From: Madrid, Shelby
Sent: Thursday, March 27, 2025 2:44 PM
To: Bumpass, Erick; Karabashian, Ani
Cc: Xie, Austin
Subject: RE: Centretech Inventory Parking Lot - Site Plan (DA-1005-33) Comment Inquiry

Subject: Centretech Inventory Parking Lot - Site Plan (DA-1005-33) Comment Inquiry

I hope you had a fantastic Wednesday. For our project case #DA-1005-33, I wanted to get some clarification on what we can do to satisfy comment 6C/6D from Fire/Life Safety.

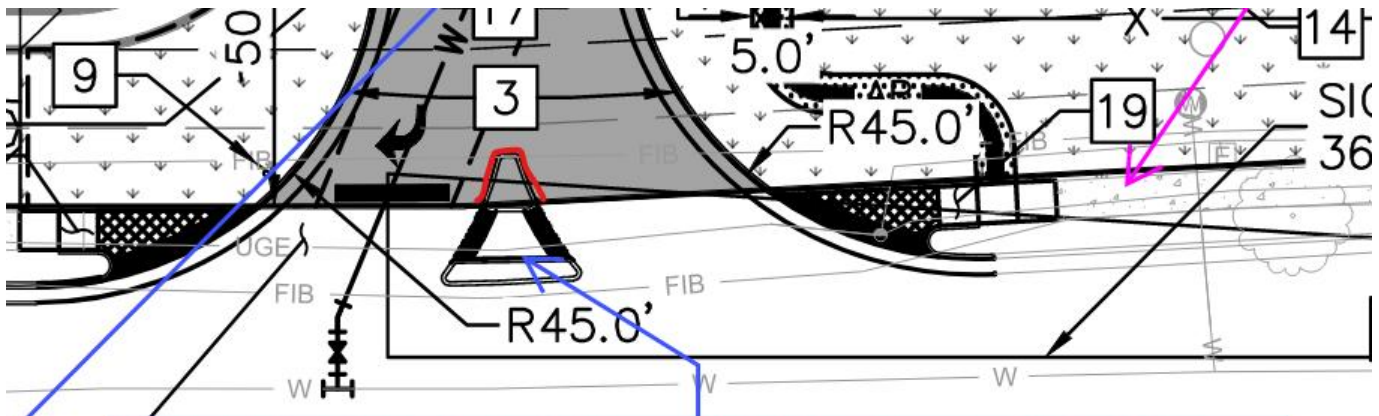
6C. The pork chop is not permitted to encroach into the Fire Lane Easement as shown. Please work with Real Property and Engineering on a License Agreement. The license agreement must be complete before this can be approved and the review completed.

Per the exhibit below – if we were to trim the fire easement around the red portion of the pork chop and leave the pork chop as it is shown, would this satisfy the comment? This change would not impact the width of the lanes for the fire apparatus into or out of our site.

The pork chop is not permitted to encroach into the Fire Lane Easement as shown. Please remove or work with real Property and Engineering on a License Agreement.- The license agreement will need to be complete before this can be approved and the review completed.

Also, if this change is acceptable – would there the pork chop details still be necessary on our site plans (Comment 6D)?

6D. Please show the Pork Chop details. Mountable? vertical? Designed for mini lbs.

Great! Thank you for checking on that! In that case, we will trim the easement around the porkchop 😊

Shelby thank you for the additional insight. I was wrong in my initial response to your previous suggestion for "trimming" around the FLE. I reached out to my coworker Mark Apodaca and spoke to him at length about this and he made me aware that it's ok in these situations with the Pork Chop to Trim it from the Easement and no License Agreement should be necessary. I apologize for my mistake and hope this is helpful.

Good afternoon. Trimming around the Pork Chop still leaves an encroachment in the easement. Have you spoken with land Development Services and or Engineering?
